Site Plan Review Committee (SPRC)
Staff Report for
685 & 701 N. Glebe – Ballston Macy’s Site

Ballston Macy's Site (SP #193)
685 & 701 N. Glebe Road
(RPC#s 14-059-038, -044, -045)

**SITE PLAN REVIEW COMMITTEE
MEETING AGENDA**

North Glebe Road street layout, from applicant’s proposal

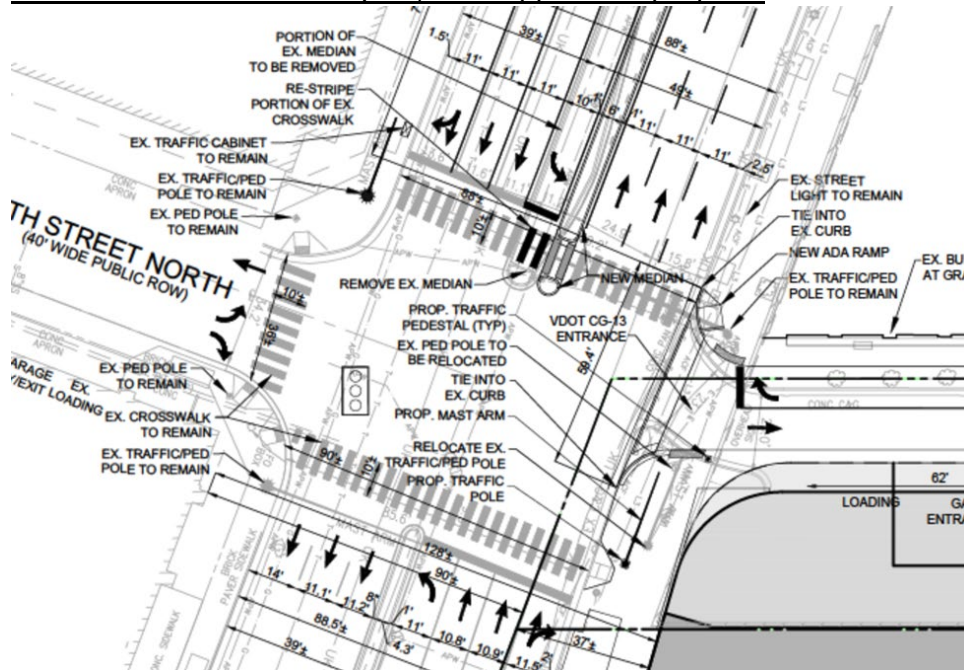
The private street, which may be a curbless environment, will have a 6’ clear pedestrian zone on the north side and a 6’ clear pedestrian zone on the south side. A pedestrian crossing from the private street across North Glebe Road is permitted on both sides, and it is signalized. However, due to street changes proposed for North Glebe Road, the crossing on the north side may be less safe than it was previously because a new pedestrian-vehicular conflict will be introduced, with left-turning vehicles entering the private street from southbound North Glebe Road conflicting with the pathway of pedestrians crossing North Glebe Road. Additionally, the creation of the left-turn lane that facilitates this new vehicular movement will necessitate the reduction of the pedestrian refuge island, from as wide as 11’ down to 6’ at the intersection crossing.

Graphic illustrating ground floor, including loading and parking entrances, from the applicant’s draft multimodal transportation assessment, September 2021.

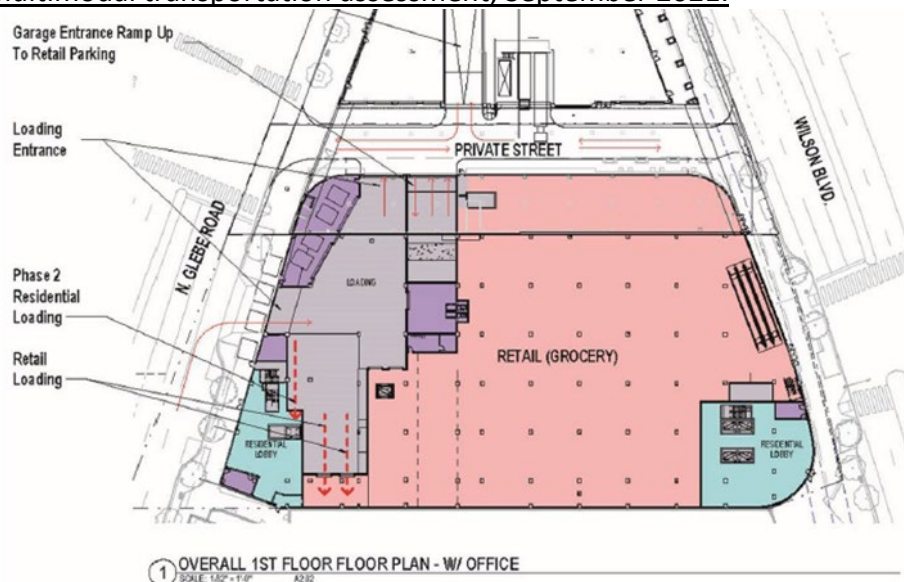
With respect to the overall pedestrian environment, the developer is placing both entrances to the grocery store along Wilson Boulevard, which will add to the vibrancy of this well-traveled street. However, the frontages facing the private street and North Glebe Road will be largely devoid of building entrances (except for an entrance to the apartment tower on Glebe Road), or much of anything to attract eye-level interest or pedestrian activity, unfortunately.
